NAVY EXPERIMENTAL DIVING UNIT

REPORT NO. 7-88

LIGHT WEIGHT DIVING SYSTEM (LWDS) PROTOTYPE
TECHNICAL EVALUATION - HUMAN FACTORS,
TRANSPORTABILITY AND SUITABILITY

Figure 2. Diesel-Compressor Unit

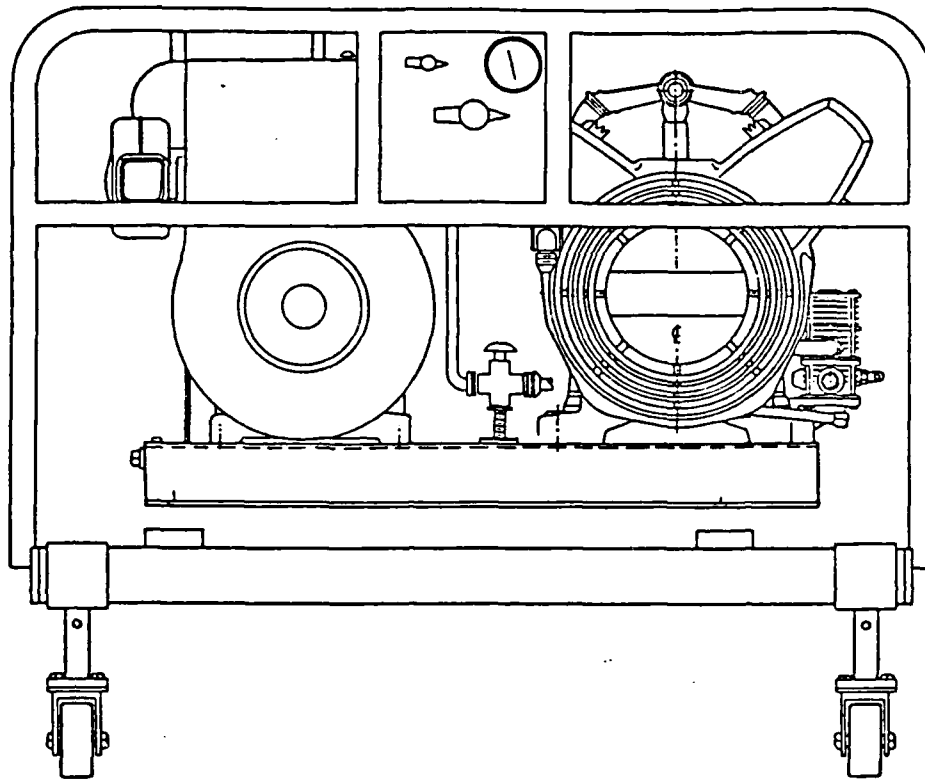
1. It was a simple system to operate.
2. The diesel-compressor unit is an extremely heavy, awkward lift for four men, that significantly exceeds MIL STD 1472C recommended limits.

4. The team was uncomfortable with the fuel tank mounted over the compressor inlet and the compressor oil filter co-centric with the inlet filter housing. Failure of the filter housing seal could result in air contamination.

Figure 5. Divers' Control Console and Volume Tank Unit

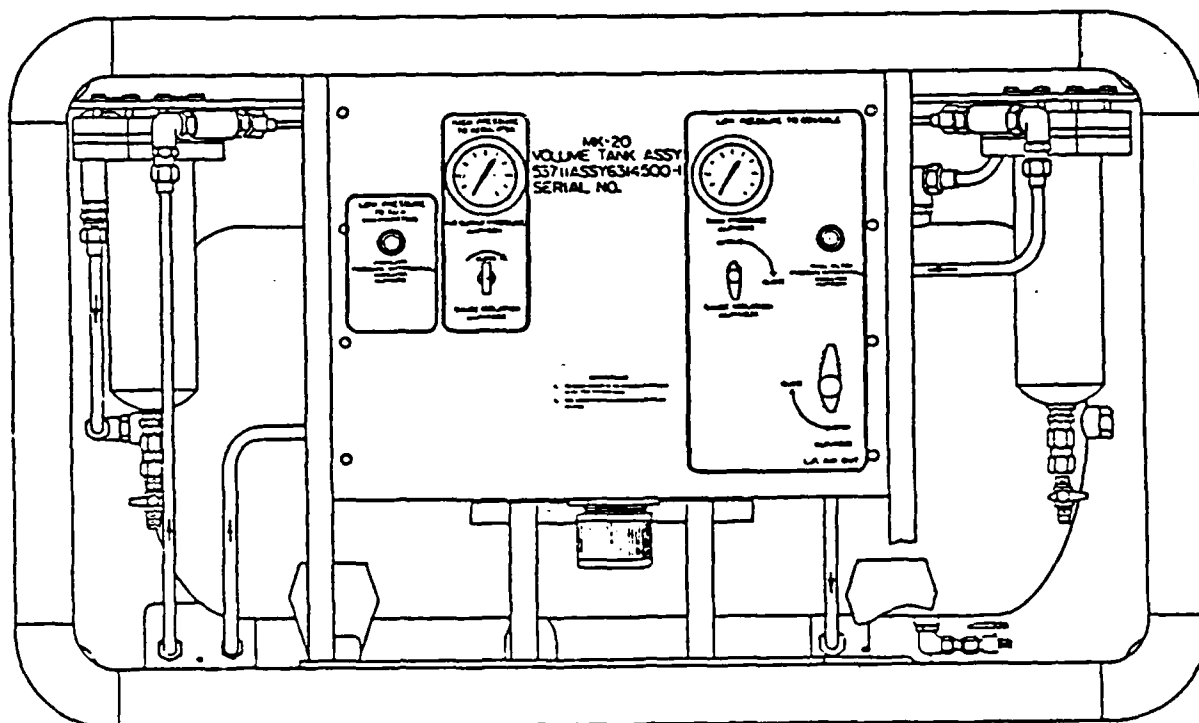
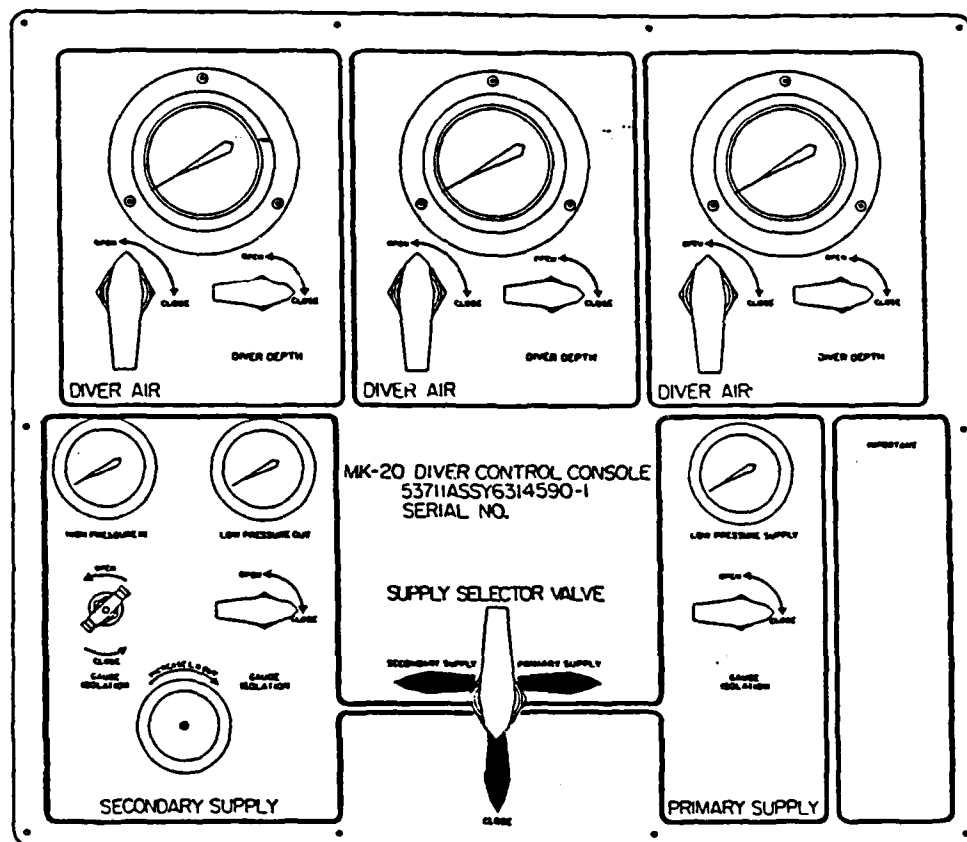
<u>REFERENCE</u>	<u>DEFICIENCY DESCRIPTION</u>	<u>SUGGESTED CORRECTION</u>
5.7.2.2	Guages on Volume Tank Unit are located less than 41 inches above the standing surface. They are extremely difficult to read.	Integrate the HP primary guages and controls into the Diver Control Con- sole as proposed in Figure 6 of the report. This would leave only the filter pressure in- dicators and the valve control and pressure guage for the Volume Tank on the lower panel.

Figure 6. Proposed Changes to the LWDS

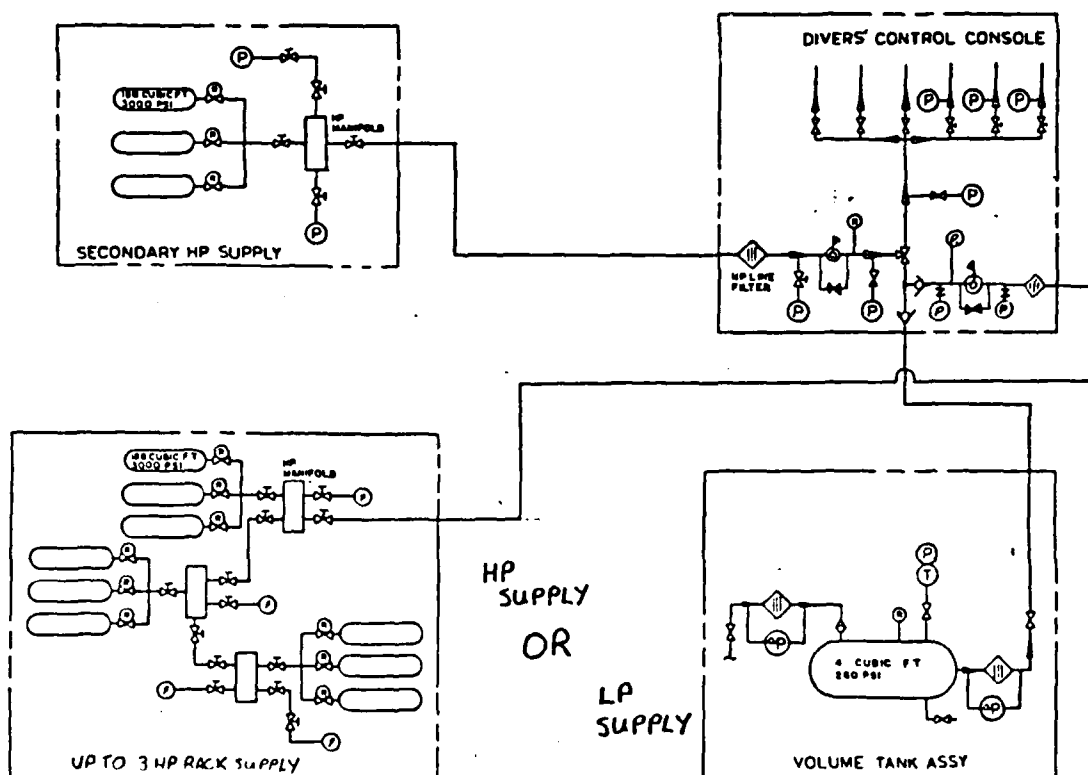
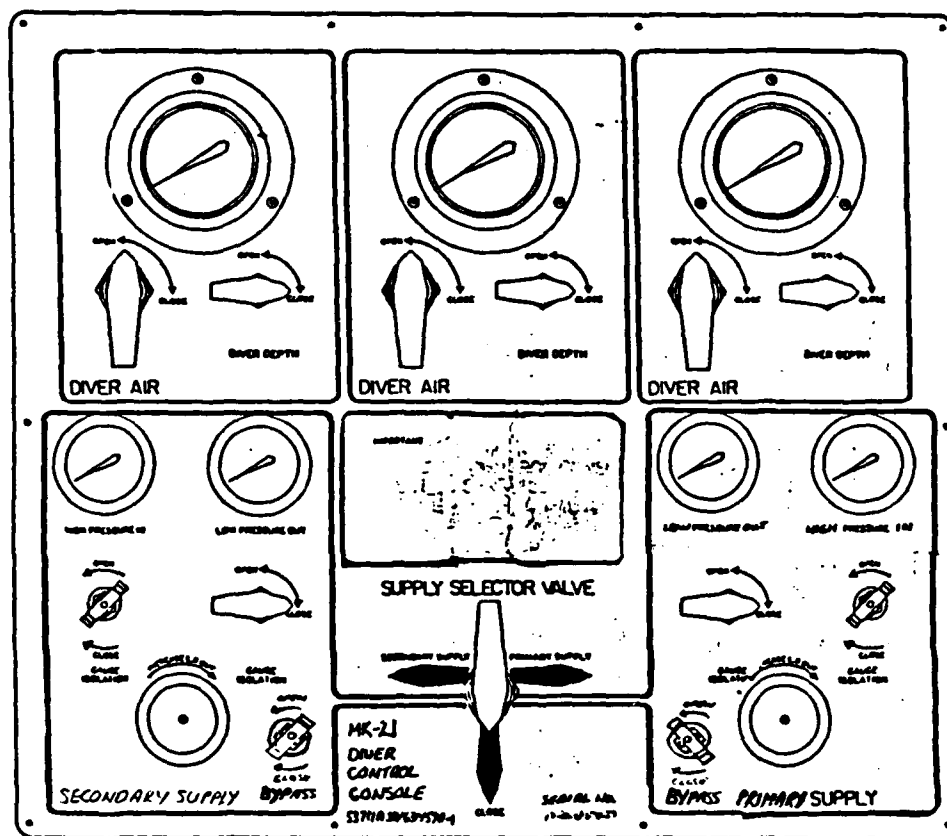
The above considerations slightly modify the prototype LWDS. If significant redesign were done, the console could be miniaturized and the HP air racks could be expanded to 4 flasks per rack with one isolated for secondary supply. Similar systems are currently in use in Canada and the United Kingdom and weigh about 400 pounds (without HP compressor).
